EXHIBIT 7

July 26, 2019

As you requested, this is a letter report on the vegetation management field inspections ("VM inspections") the Monitor team is conducting pursuant to the Court's April 3, 2019 Order ("April 3 Order"). This submission includes: (1) background information on the VM inspections; (2) an explanation of the VM inspections process; (3) the Monitor team's preliminary observations; (4) PG&E's feedback based on the Monitor team's preliminary findings; (5) the Monitor team's preliminary suggestions to PG&E, as shared with the Company on July 17, 2019; and (6) concluding thoughts.

I. OVERVIEW AND BACKGROUND

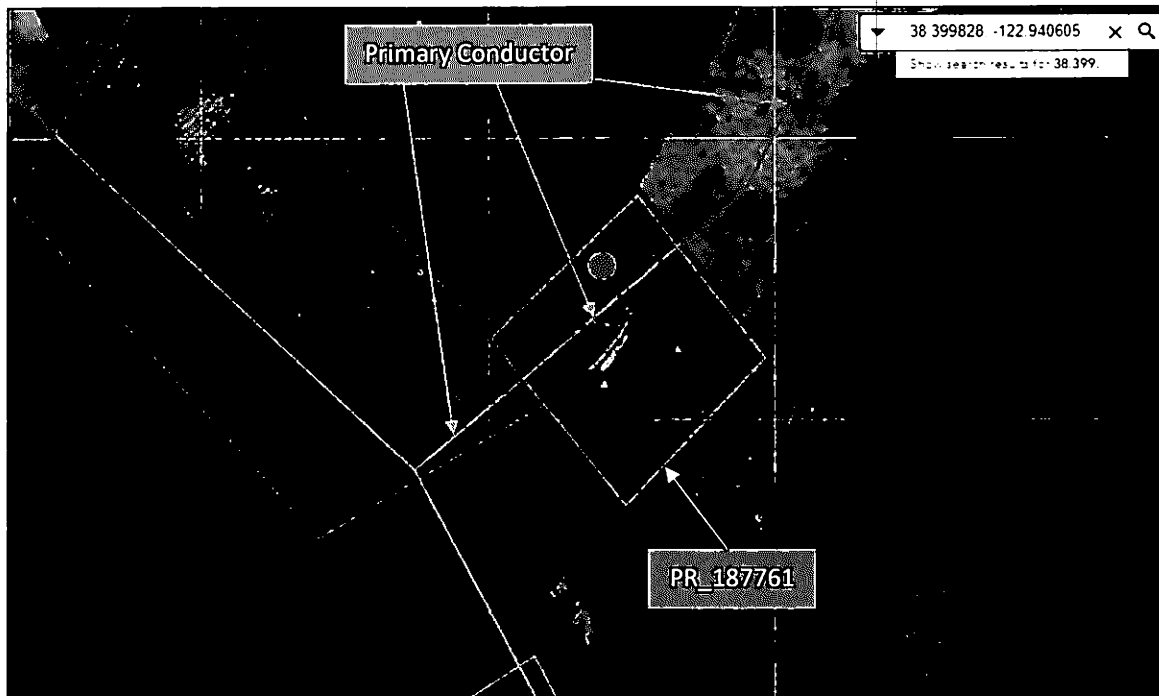
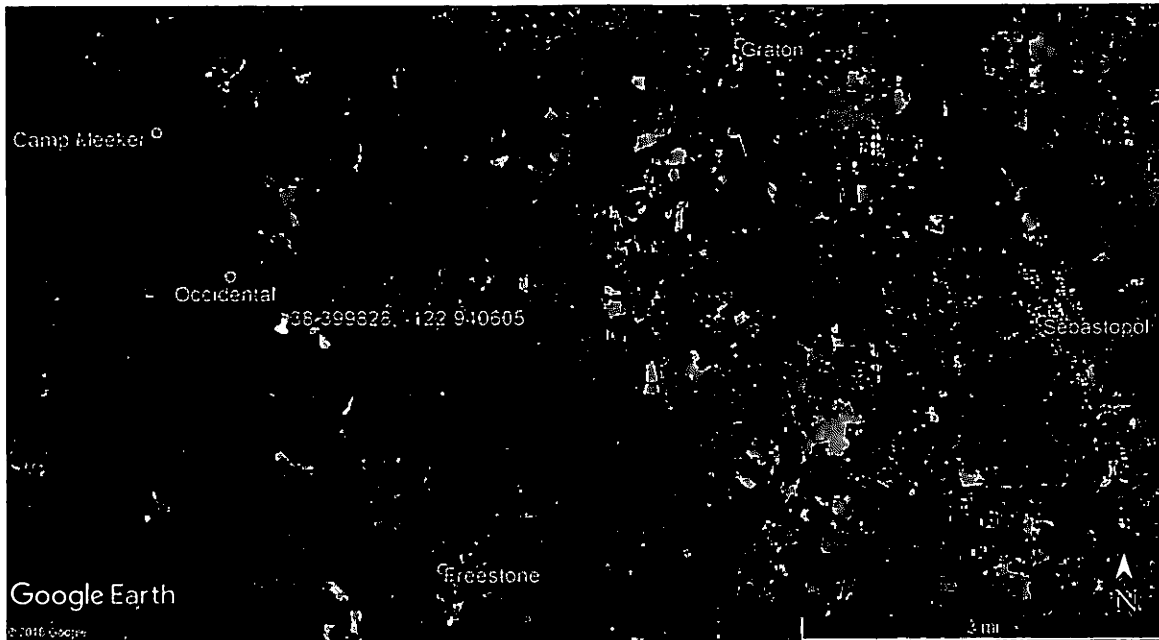
A potential hazard tree was found during a Monitor Inspection on July 11, 2019 of Project *PR_187761* on Circuit *Molino 1102*. In general terms, this circuit is located on the outskirts of the city of Sebastopol, CA, running approximately 10 miles to the west of the city. This circuit is located in/near a Tier 3 fire threat area pursuant to the ArcCollector database. The approximate position of the tree is denoted as the red circle in the second graphic below.

PG&E ArcCollector Project Status	Work Identified	
Monitor Team Observed Tree Work in Immediate Vicinity of Subject Tree	No	
Monitor Team Observed Recent Tree Work on Subject Tree	No	
Tree Paint or Other Markings Observed	No	
Species	California Bay	
GPS Coordinates	38.399828, -122.940605	
Approx. Distance from Primary Conductor	Trunk of tree 14 feet northwest	
Approx. Height	70 feet	
Veg Type	Potential Hazard Tree	
Monitor Arborist Comment	Observations of the tree include (a) weak multi-stemmed tree structure, (b) soil eroded around roots leading to poor anchorage, and (c) tree is overhanging line at 15 ft.

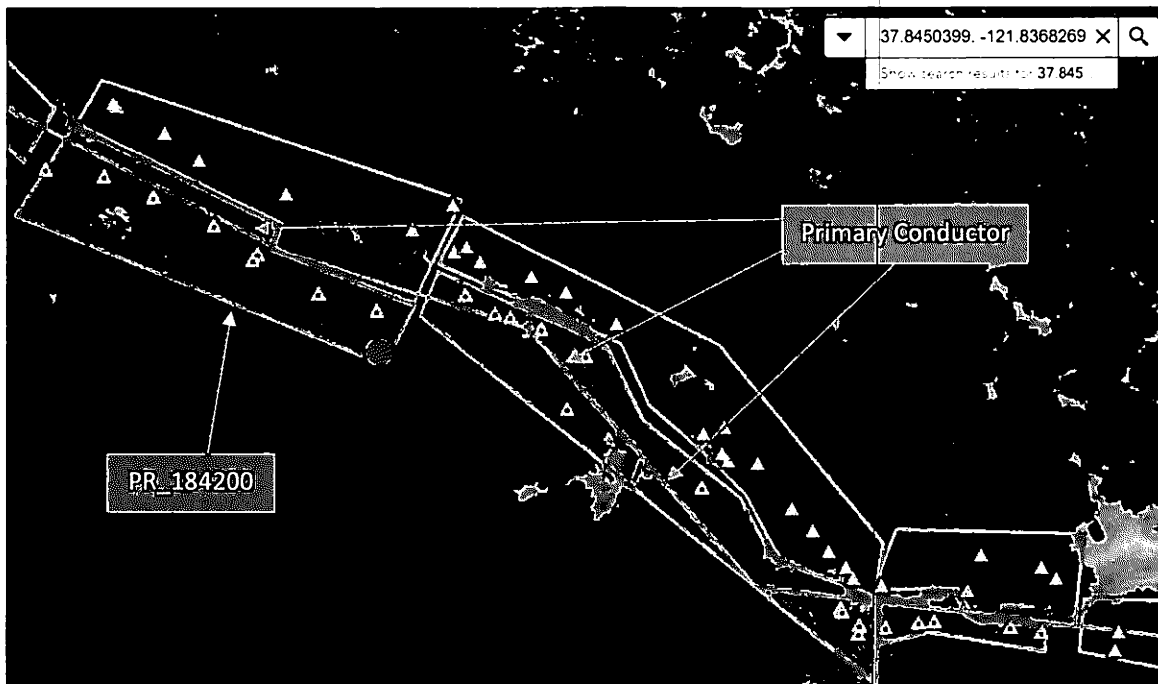
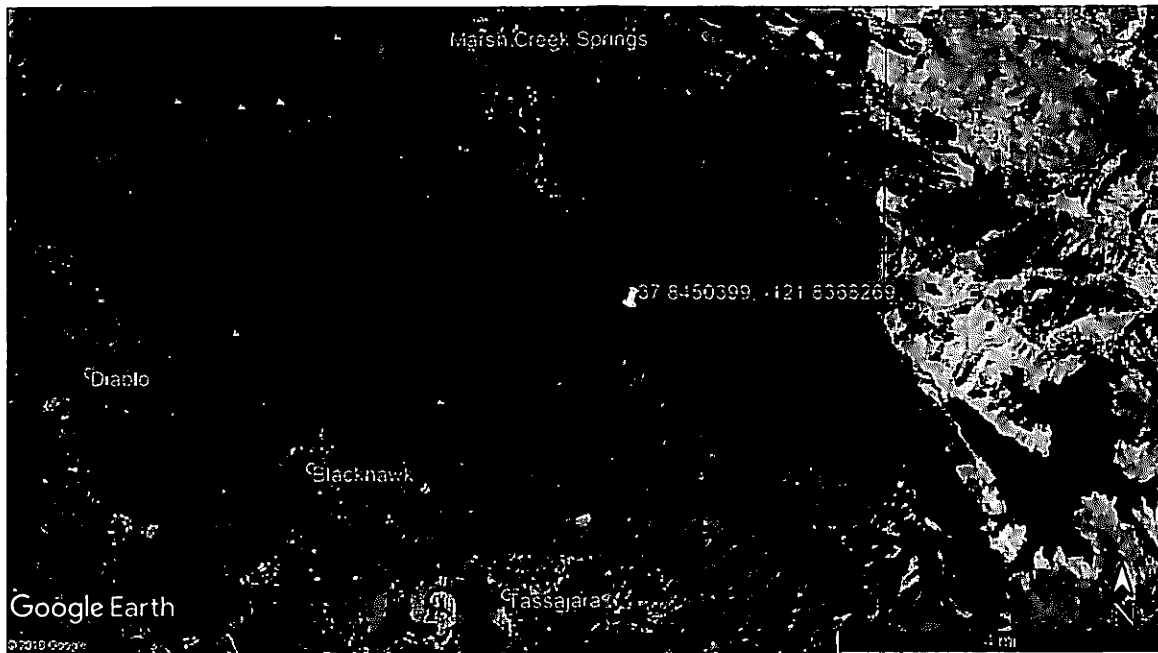
A tree with a potential overhang issue was found during a Monitor Inspection on June 6, 2019 of Project *PR_184200* on Circuit *Clayton 2212*. In general terms, this circuit is located on the outskirts of the town of Clayton, CA, running approximately 15 miles to the southeast of town. This circuit is located in/near a Tier 3 fire threat area pursuant to the ArcCollector database. The approximate position of the tree is denoted as the red circle in the second graphic below.

PG&E ArcCollector Project Status	Wood Mgmt Complete
Monitor Team Observed Tree Work in Immediate Vicinity of Subject Tree	Yes
Species	Ponderosa Pine
GPS Coordinates	37.8450399, -121.8368269
Approx. Distance from Primary Conductor	Trunk of tree 15 feet west
Approx. Height	150 feet
Veg Type	Potential Overhang Tree
Monitor Arborist Comment	Vegetation observed currently overhanging the 4 foot vertical plane

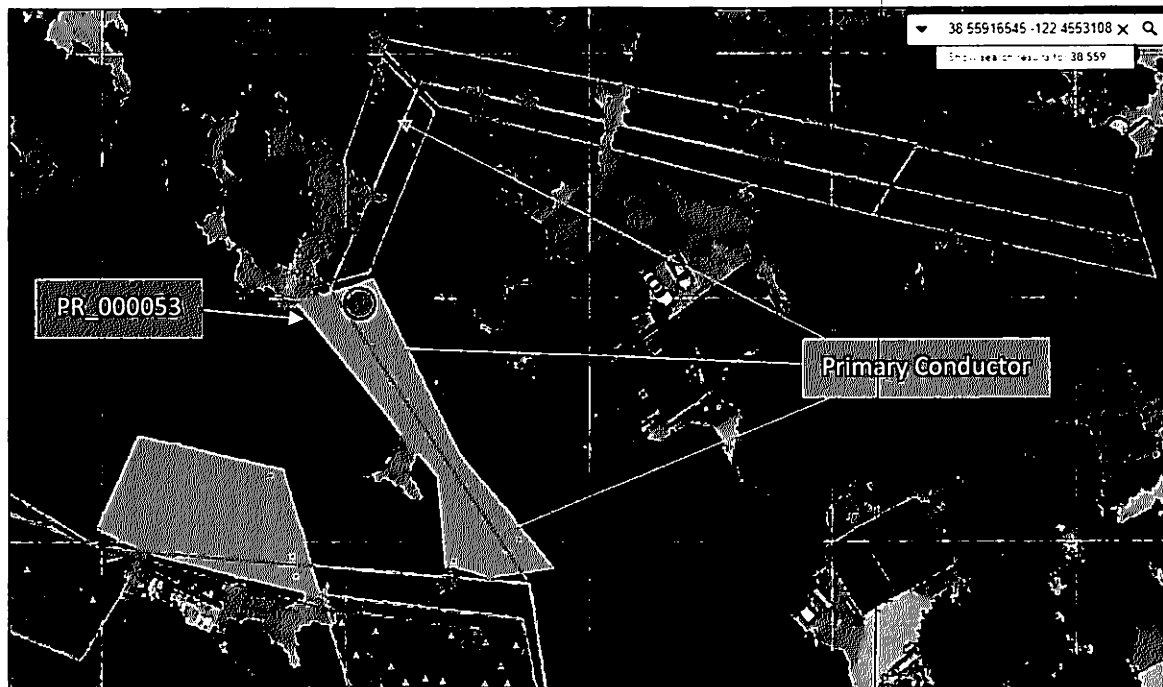
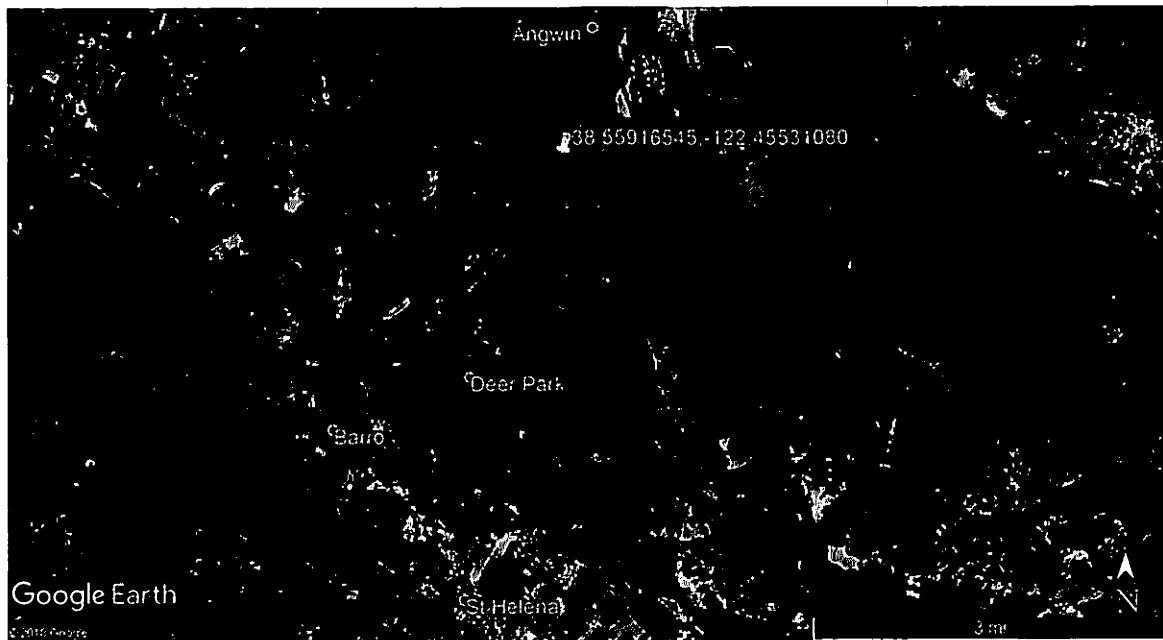
A potential overhang tree was found during a Monitor Inspection on July 3, 2019 of Project *PR_000053* on Circuit *Silverado 2104*. In general terms, this circuit is located on the outskirts of the city of St. Helena, CA, running approximately 15 miles to the north of the city. This circuit is located in/near a Tier 3 fire threat area pursuant to the ArcCollector database. The approximate position of the tree is denoted as the red circle in the second graphic below.

PG&E ArcCollector Project Status	Tree Work Complete	
Monitor Team Observed Tree Work in Immediate Vicinity of Subject Tree	Yes	
Monitor Team Observed Recent Tree Work on Subject Tree	Yes	
Tree Paint or Other Markings Observed	Red dot	
Species	Ponderosa Pine	
GPS Coordinates	38.55916545, -122.45531080	
Approx. Distance from Primary Conductor	Trunk of tree 18 feet east	
Approx. Height	102 feet	
Veg Type	Potential Overhang Tree	
Monitor Arborist Comment	Vegetation observed currently overhanging the 4 foot vertical plane.

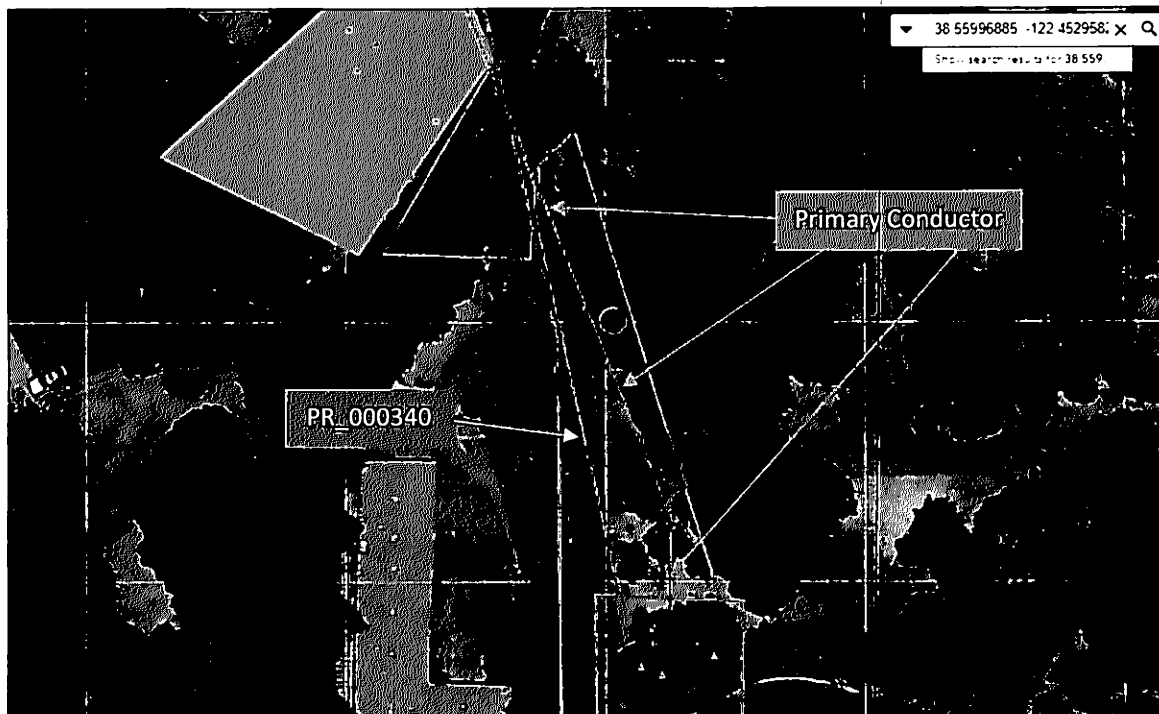
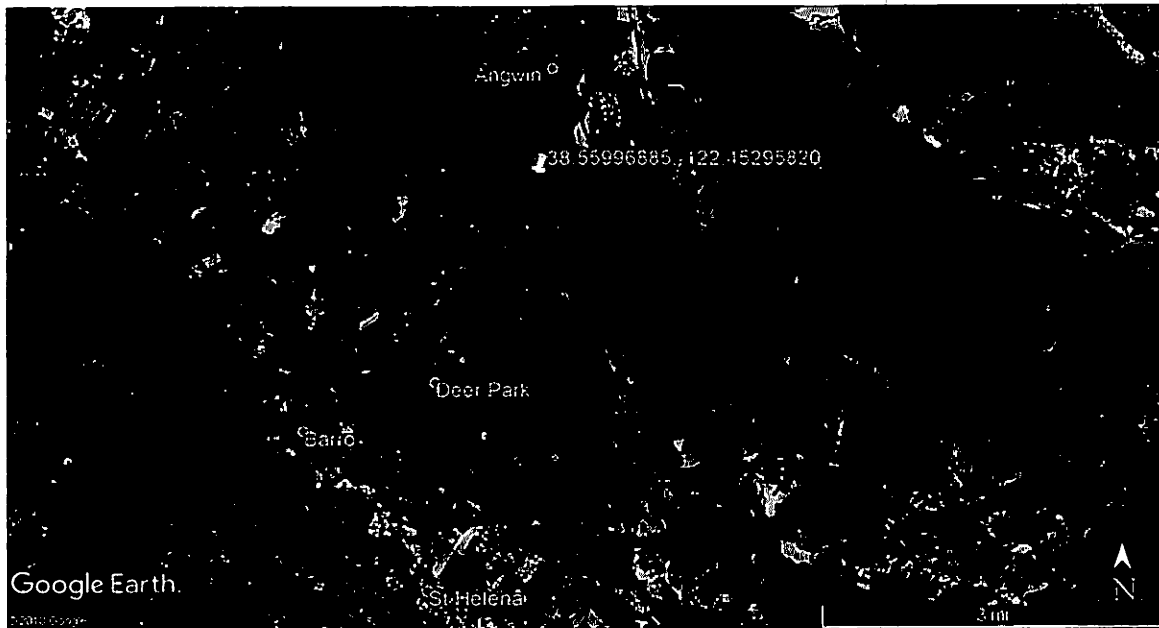
A potential overhang tree was found during a Monitor Inspection on July 3, 2019 of Project *PR_000340* on Circuit *Silverado 2104*. In general terms, this circuit is located on the outskirts of the city of St. Helena, CA, running approximately 15 miles to the north of the city. This circuit is located in/near a Tier 3 fire threat area pursuant to the ArcCollector database. The approximate position of the tree is denoted as the red circle in the second graphic below.

PG&E ArcCollector Project Status	Work Identified	
Monitor Team Observed Tree Work in Immediate Vicinity of Subject Tree	No	
Monitor Team Observed Recent Tree Work on Subject Tree	No	
Tree Paint or Other Markings Observed	No paint observed	
Species	Ponderosa Pine	
GPS Coordinates	38.55996885, -122.45295820	
Approx. Distance from Primary Conductor	Trunk of tree 8 feet east	
Approx. Height	115 feet	
Veg Type	Potential Overhang Tree	
Monitor Arborist Comment	Vegetation observed currently overhanging the 4 foot vertical plane, and tree not visibly marked for pruning.

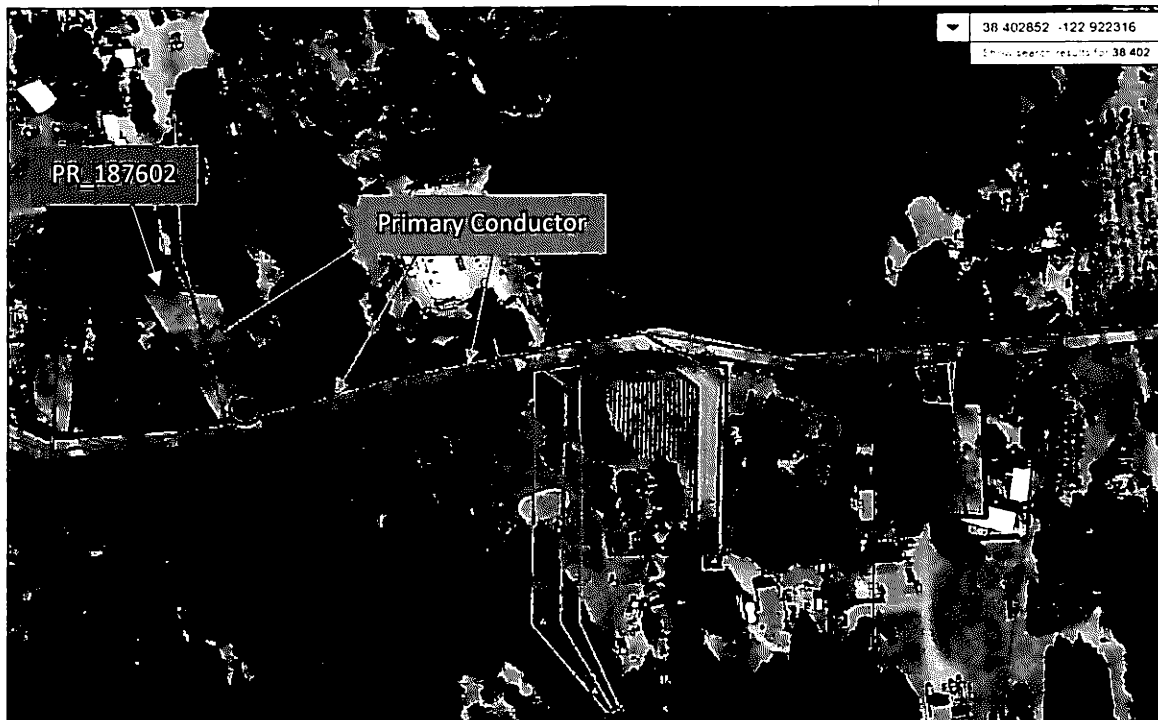
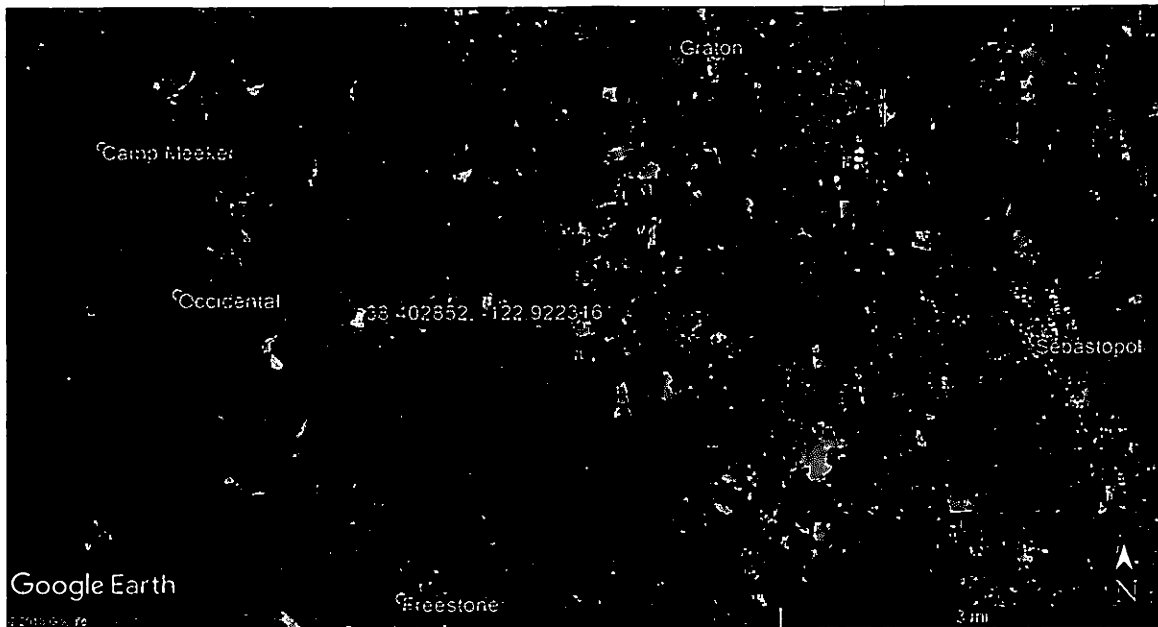
A potential overhang tree was found during a Monitor Inspection on July 2, 2019 of Project *PR_187602* on Circuit *Molino 1102*. In general terms, this circuit is located on the outskirts of the city of Sebastopol, CA, running approximately 10 miles to the west of the city. This circuit is located in/near a Tier 3 fire threat area pursuant to the ArcCollector database. The approximate position of the tree is denoted as the red circle in the second graphic below.

PG&E ArcCollector Project Status	No Work Required Under EVM
Monitor Team Observed Tree Work in Immediate Vicinity of Subject Tree	No
Species	Coastal Redwood
GPS Coordinates	38.402852, -122.922316
Approx. Distance from Primary Conductor	Trunk of tree 5 feet north
Approx. Height	115 feet
Veg Type	Potential Overhang Tree
Monitor Arborist Comment	Vegetation observed currently overhanging the 4 foot vertical plane

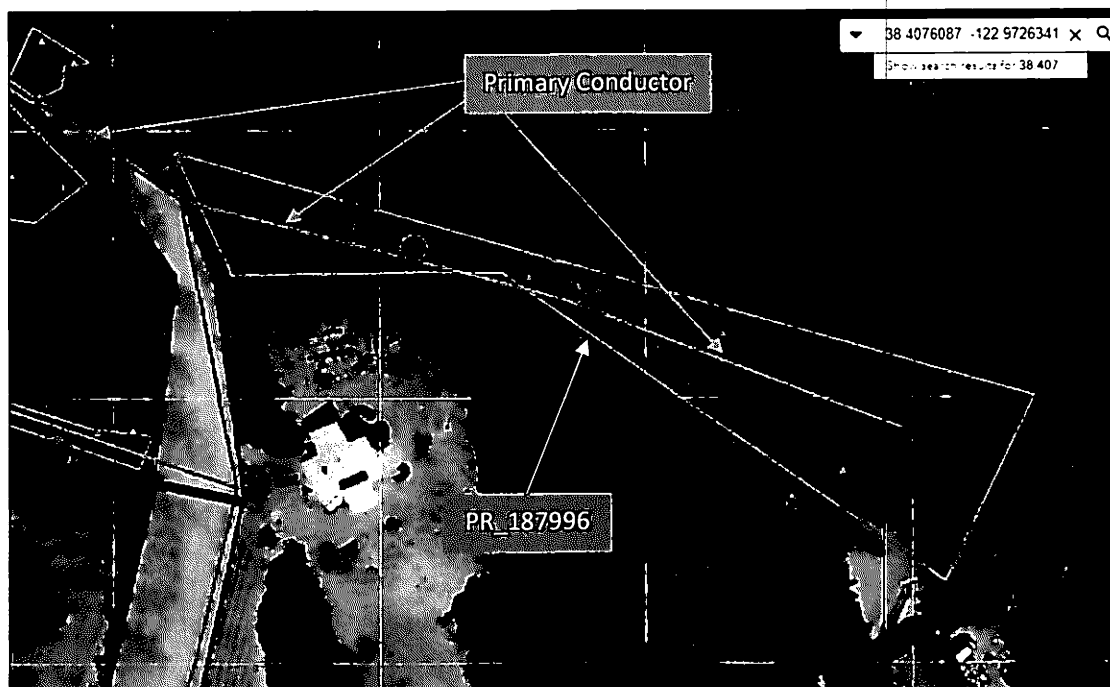
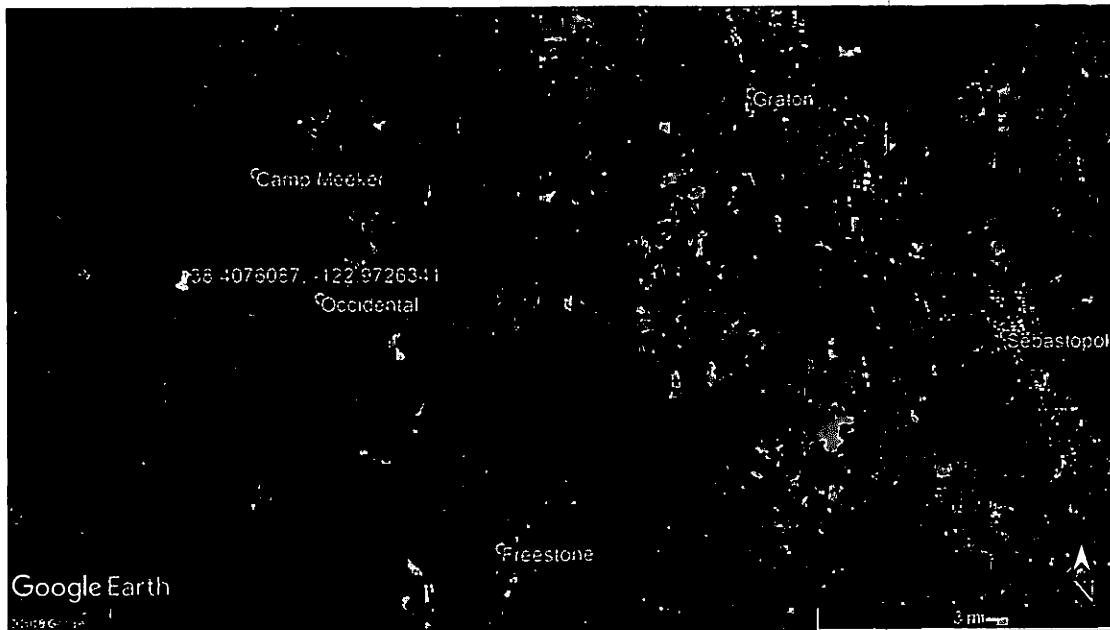
A potential overhang tree was found during a Monitor Inspection on July 1, 2019 of Project *PR_187996* on Circuit *Molino 1102*. In general terms, this circuit is located on the outskirts of the city of Sebastopol, CA, running approximately 10 miles to the west of the city. This circuit is located in/near a Tier 3 fire threat area pursuant to the ArcCollector database. The approximate position of the tree is denoted as the red circle in the second graphic below.

PG&E ArcCollector Project Status	Work Identified
Monitor Team Observed Tree Work in Immediate Vicinity of Subject Tree	No
Monitor Team Observed Recent Tree Work on Subject Tree	No
Tree Paint or Other Markings Observed	No paint observed
Species	Coastal Redwood
GPS Coordinates	38.4076087, -122.9726341
Approx. Distance from Primary Conductor	Trunk of tree 3 feet north
Approx. Height	120 feet
Veg Type	Potential Overhang Tree
Monitor Arborist Comment	Vegetation observed currently overhanging the 4 foot vertical plane, and tree not visibly marked for pruning.
